Addendum Number 3
Laramie County Community College
South Irrigation System Rehabilitation
January 9, 2017

Pre-Bid Contractor questions and responses:

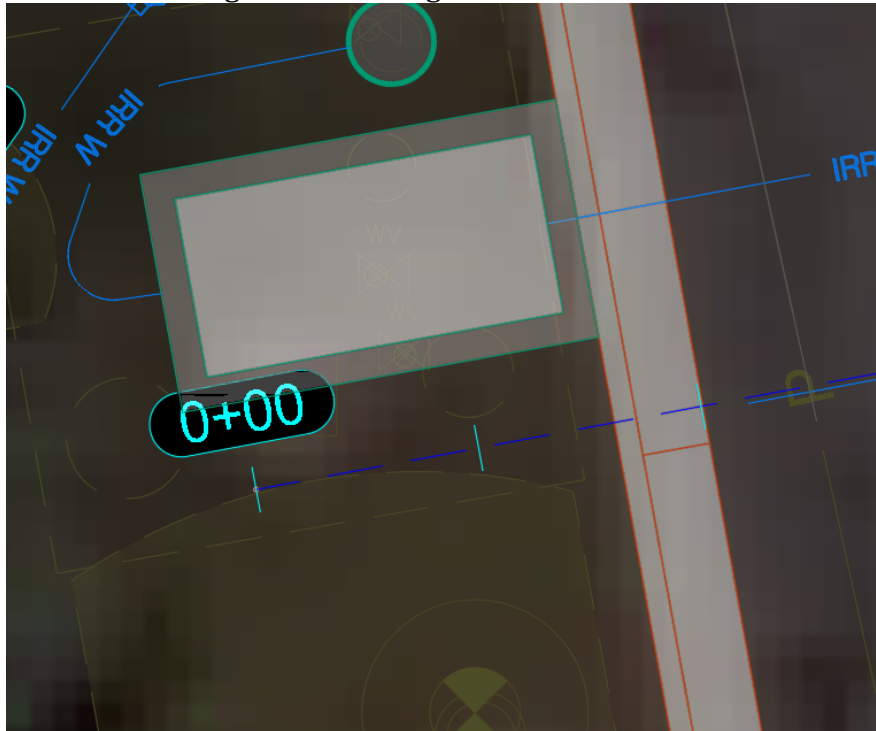
- 9) Clarify replacement of existing concrete filled vent.

- a) As per contract documents, verify vent of existing water storage tank is not obstructed. Anticipate replacing above grade elbow.
- 10) Clarify the use of pea gravel as backfill for tanks.

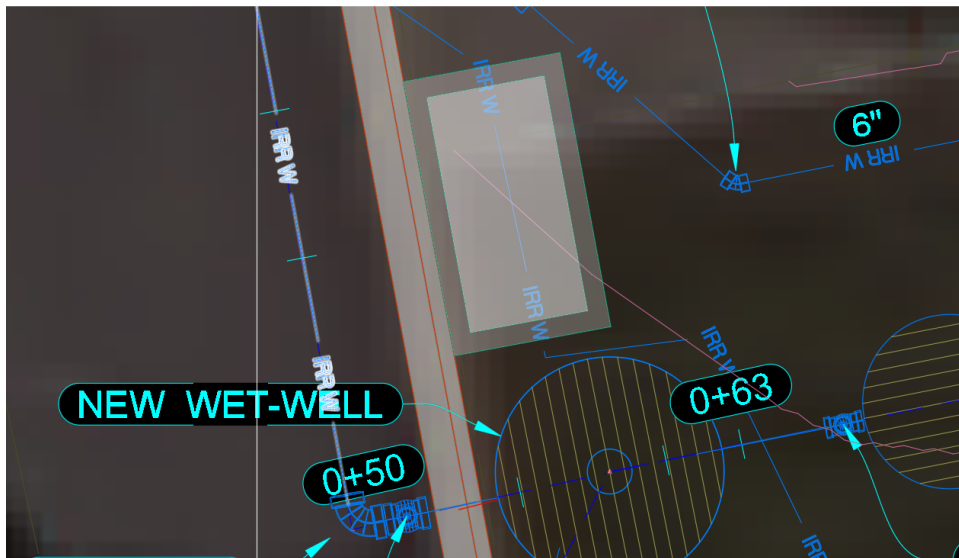
19) Clarify vault size and location for Vault-A.

- a) Anticipated vault size is 6' wide x 8' long.
- b) Options for locating Vault A include:
 - i) Between existing Tank and irrigation well – oriented behind curb on west island

- ii) On east curb island north of new wet-well
